CAIRNGORMS NATIONAL PARK AUTHORITY

Title: UPGRADE OF ELECTRICITY TRANSMISSION LINE FROM BEAULY TO DENNY:

PRE-APPLICATION CONSULTATION ON THE PREFERRED ROUTE.

**Prepared by: NORMAN BROCKIE, PLANNING OFFICER
(Local Plan/Policy)**

Diagram 1: Map of the proposed route.

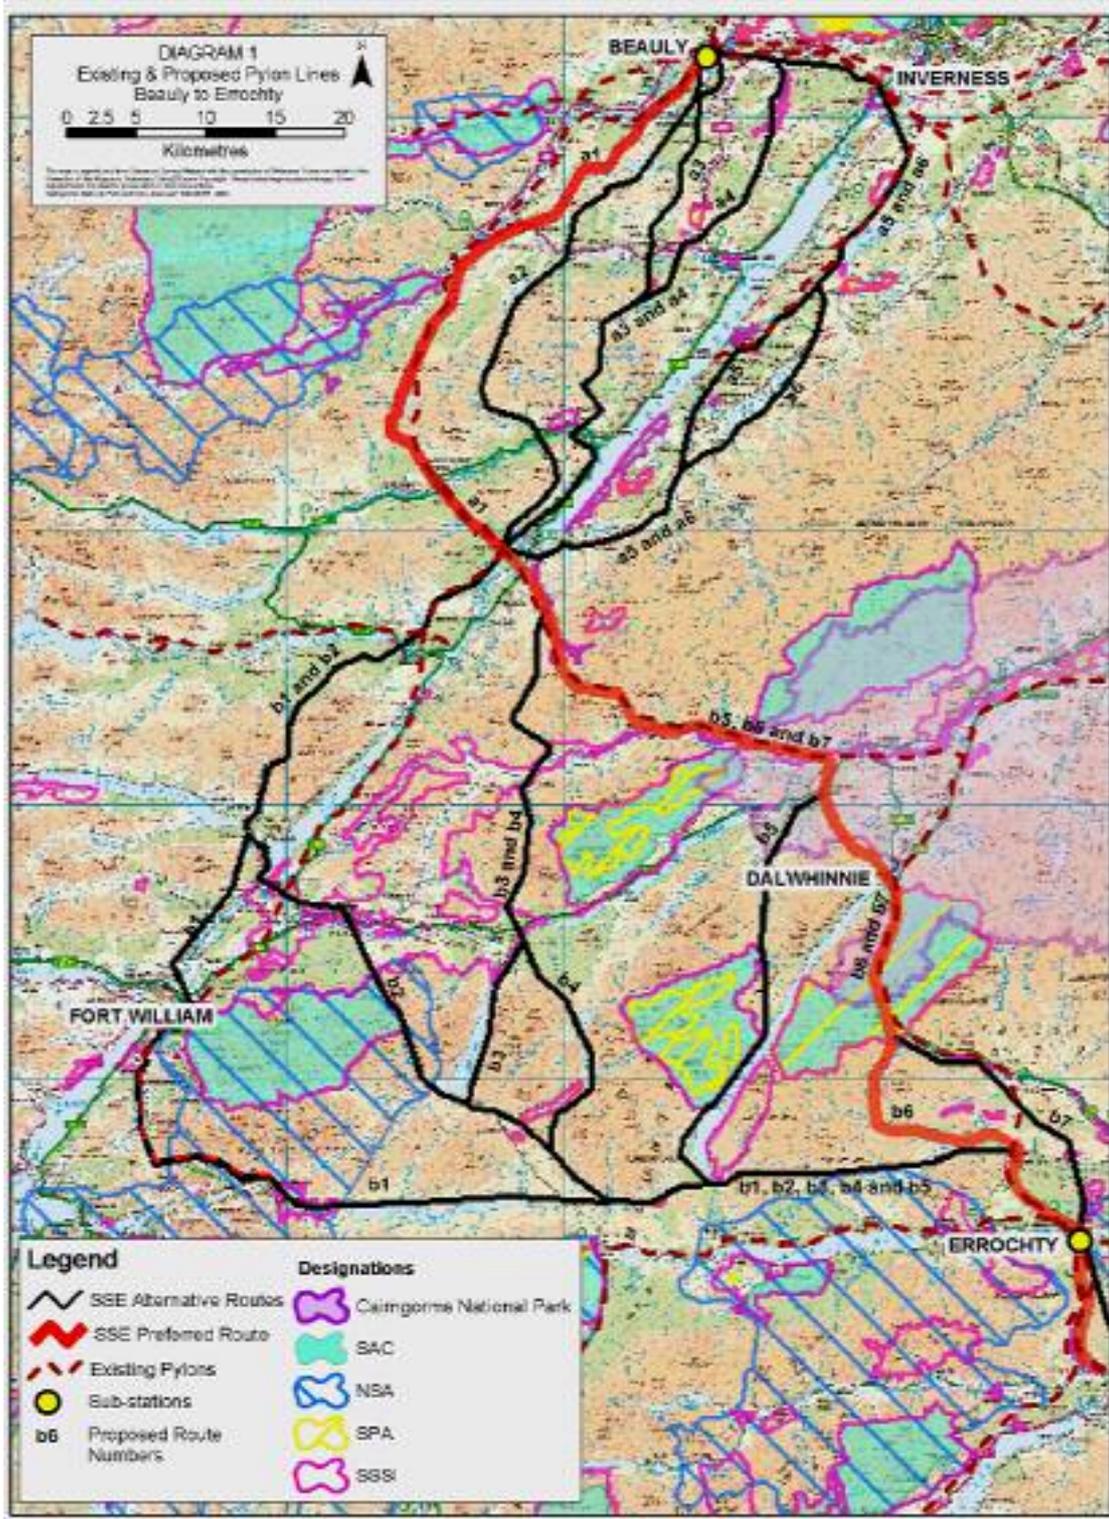
The upgrading of this transmission line will cause a considerable adverse impact on the landscape of the Park, natural heritage, and on the Dalwhinnie and Laggan area communities. An alternative route should be considered (b4 on Diagram 1) which will completely avoid the National Park, NSA's and most designated sites; it would also be much less visible.

4. The preferred route has several other options in the section from Fort Augustus to Errochty, see Diagram 1; this is however a superbly scenic area with many designated sites, and there is no easy option for a new route. The fact that the preferred route mostly follows the line of the existing pylons does swing in its favour, as new development on wild land/designated sites is minimised, and people may be accustomed to the pylons. Many of the other options would require considerable infrastructure & access development just to get near the sites, often disrupting 'wild land'. Option b4, for example, avoids almost all designated areas but mostly crosses through remote country.

10. There are many issues being raised by the routing of this development, issues which could be avoided if the line was re-routed (as b4 on Diagram 1); the argument against this will most likely be that most of the route is remote and will require considerable access infrastructure to be built to facilitate construction. The applicant may be reluctant to incur the costs associated with this rather than the 'preferred' (and cheaper) option, which itself will come at a high price to the landscape and communities of the National Park. The reasons for not choosing route b4 should be more fully justified by the applicant, with a financial comparison.

Diagram 2: detail plan of preferred route via Strathmashie and Dalwhinnie.

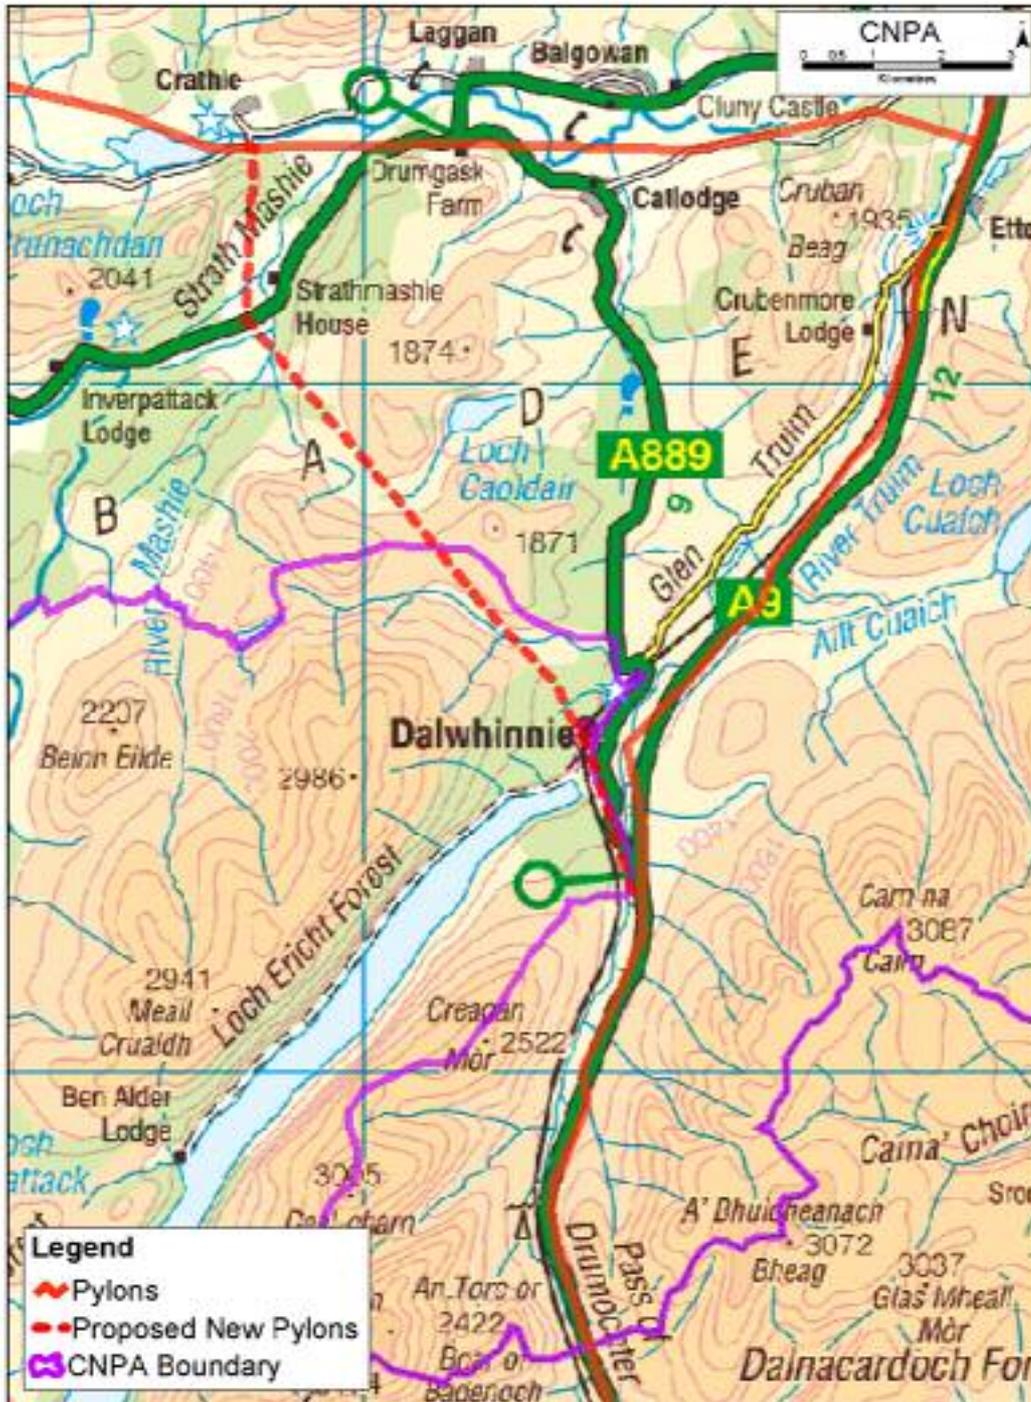
5. The proposed route over the hill from Strathmashie to Dalwhinnie would have seriously adverse impacts on the landscape, crossing at a shallow gap on the hill/skyline at an elevation of 500m (see photo 1). A better option may be to follow the existing 'valley floor' route, which will also alleviate the problem in point 6. It may be possible, and relatively straightforward, to under-ground much of this section.

6. The village of Dalwhinnie is currently skirted by the existing pylon line, which does not cross the River Truim. The new pylon route appears to pass between the village and the head of Loch Erich; the impact this will have on the village will be considerable. The new 45/50m pylons can be spaced over 300metres apart, which may allow for careful spacing to minimise impact, but general proximity to housing may still be a serious problem; under-grounding of the cables may be the best option in this area.

The preferred route effectively cuts the length of the existing route by approx. 50%, but comes over the hill and passes through the Dalwhinnie settlement.
